# SERVICE BULLETIN

M-978

## SAFETY RECALL CODE 066 1989 XL POSITIVE BATTERY CABLE

**Figure 1. Boot Mounting**

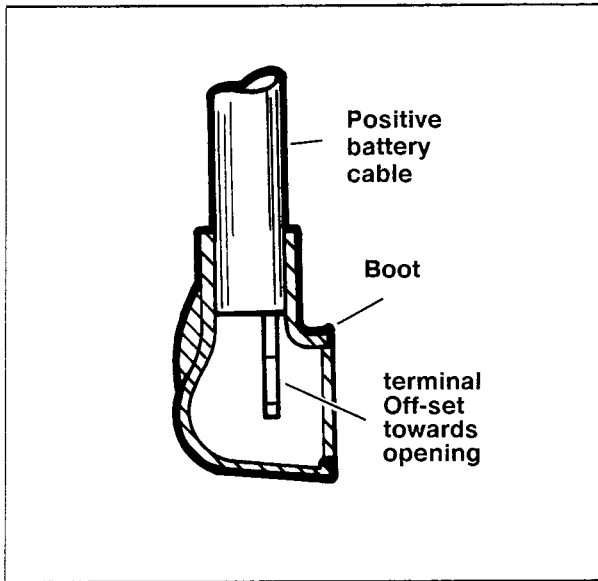
Harley-Davidson, Inc. has become aware the possibility exists that the positive battery cable used on some 1989 XL model motorcycles could develop a short circuit due to excessive wear and chafing if routed in a certain position. If this occurred the battery cable might overheat possibly to a degree which might cause a vehicle fire.

As a precautionary measure Harley-Davidson has elected to initiate a voluntary recall campaign in the interest of motor vehicle safety. The potential problem will be remedied by replacing the positive battery cable on the potentially affected vehicles with a longer cable using a revised routing. This recall applies to 1989 XL model motorcycles manufactured at our York, Pennsylvania assembly plant from the beginning of the 1989 model year May 20, 1988, through December 11, 1988.

6. See Figure 1. Using the new cable supplied in the kit, roll open end of boot back onto cable exposing ring terminal end.
7. Attach large ring terminal to starter stud with lockwasher and 12 mm. nut. Tighten nut with socket and flex driver. Roll boot back down over starter terminal.
